ABWR

Subject Info on HECW system

Message the attached sheets provide  
the info you requested today  
These two sheets replace the  
ones sent to you by Fox on  
4/29/92.

23A6100AH  
REV. B

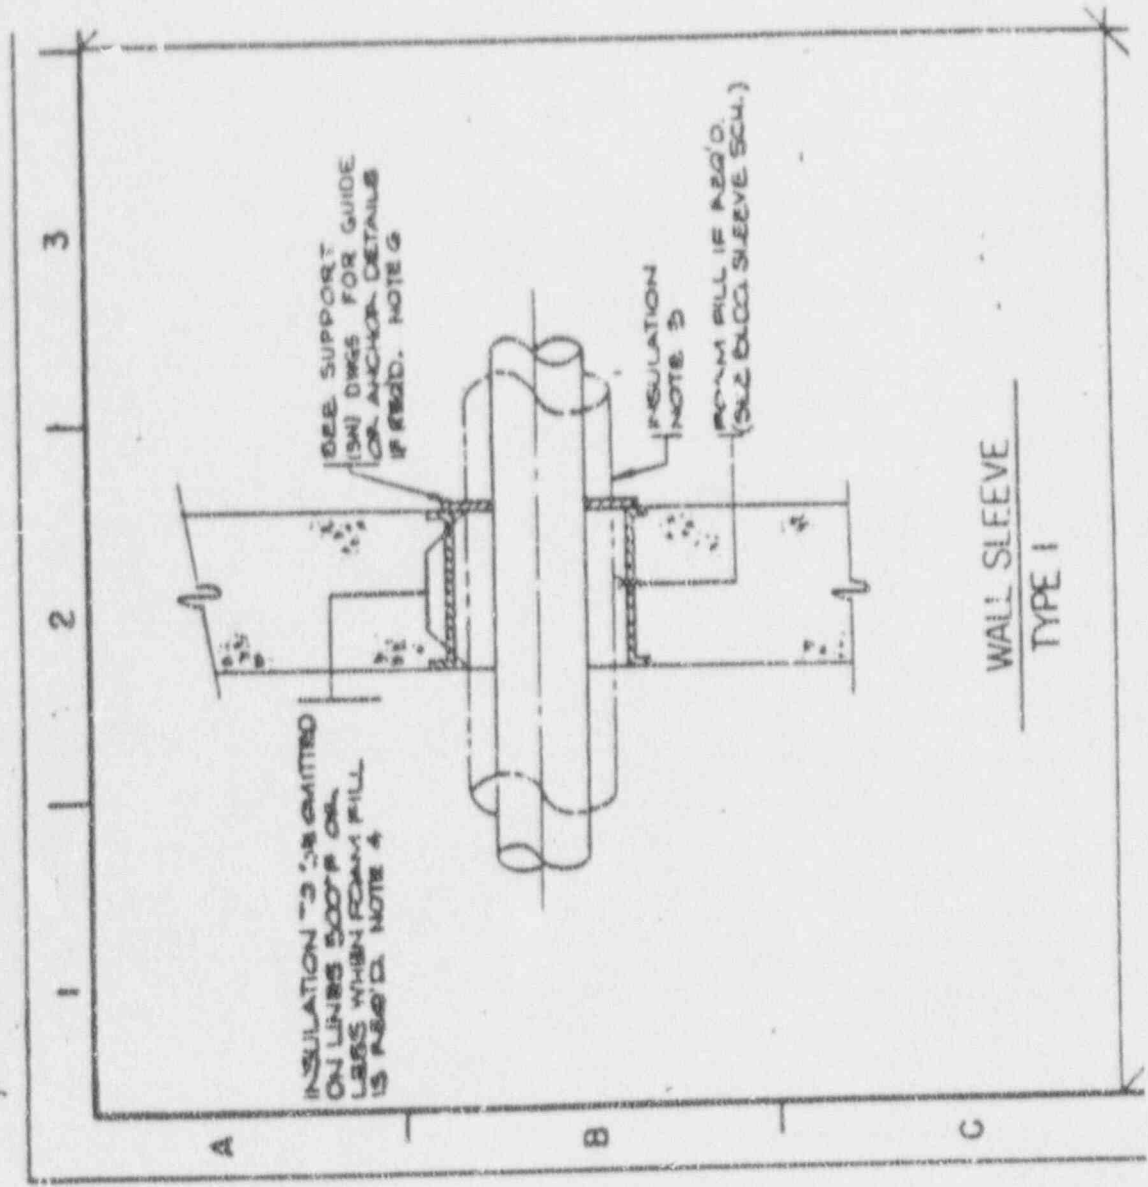
controlled by a temperature control valve. The ~~subsystems are designed~~ Division I and Division H power, respectively. One compressor is the operating unit, while the other is on standby. Condenser cooling is from the corresponding division of RCW.

High temperature of the returned cooling water causes the standby chiller <sup>refrigerant</sup> to start automatically. Makeup water is supplied from the MUWP system, at the surge tank. Each surge tank has the capacity to replace system water losses for more than 100 days during an emergency.

Initial testing of the system includes performance testing of the <sup>refrigerant</sup> chillers, pumps and coils for conformance with design capacity water flows and heat transfer capabilities. An integrity test is performed on the system upon completion.

The HVAC emergency cooling water system consists of ~~redundant~~ <sup>refrigerant</sup> subsystems in three divisions. Each ~~division consists of~~ <sup>refrigerant</sup> two 50% chiller units, two 50% pumps, instrumentation and distribution piping and valves to corresponding cooling coils. A chemical addition tank is shared by all HECW divisions. Each HECW division shares a surge tank with the corresponding division of the RCW system. The ~~chiller capacity is designed to cool all heat loads with two chillers, but also cool the heat load of the main control room with one chiller.~~ <sup>refrigerant</sup>

**AA** → Equipment is listed in Table 9.2-9. Each cooling coil has a three-way valve controlled by a room thermostat. Alternately, flow may be

\* Division A has one <sup>refrigerator</sup> chiller and pump and divisions B and C have  
 \*\* the diesel generator zone and electrical equipment room

(A) → The only non-safety-related portions of the HECW divisions are the chemical addition tank and the piping from the tank to the safety related valves which isolate the safety related portions of the system.

(AA) → The system is shown in Figure 9.2-3. The refrigerators are located in the control building as shown in Figures 1.2-20 and 1.2-21. This system shares the RCW surge tanks which are in the reactor building as shown in Figure 1.2-12.
